工程指示 / 要求簡箋(E.I.)

工程指示編號 : EI / 5733 / 23

工程名稱 : 將軍澳日出康城 11

工程項目 : 幕牆 拆圖修改 大飾線 X86307 加 6 x 20 去水孔

1 TYPICAL TRANSOM DETAIL CURTAIN WALL D51

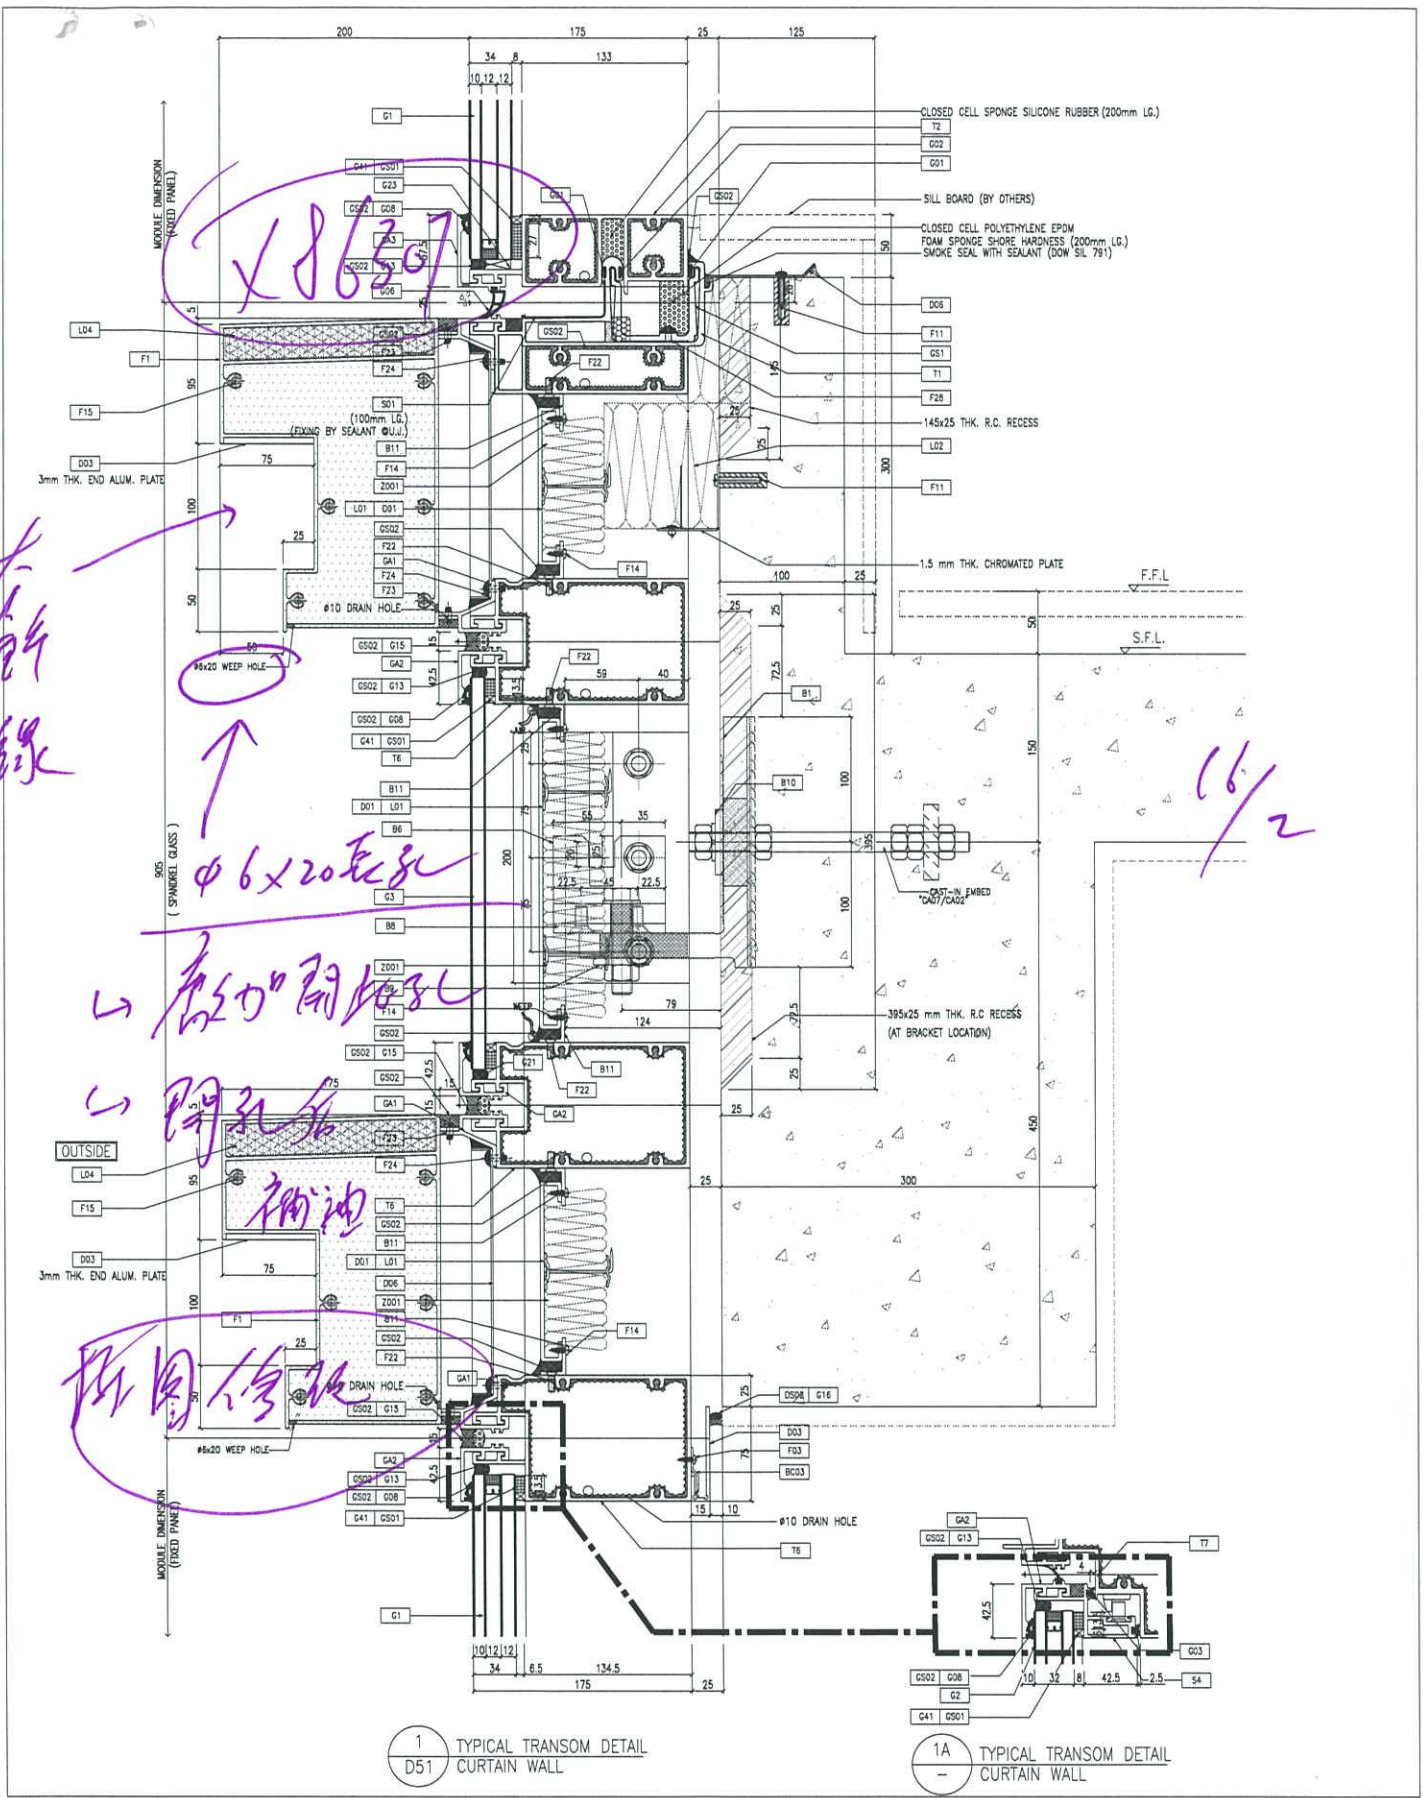
業主 comment 飾線去水孔, 飾線要按圖加做 6x20 長孔。離邊 100mm
 注明: 開孔後廠點油
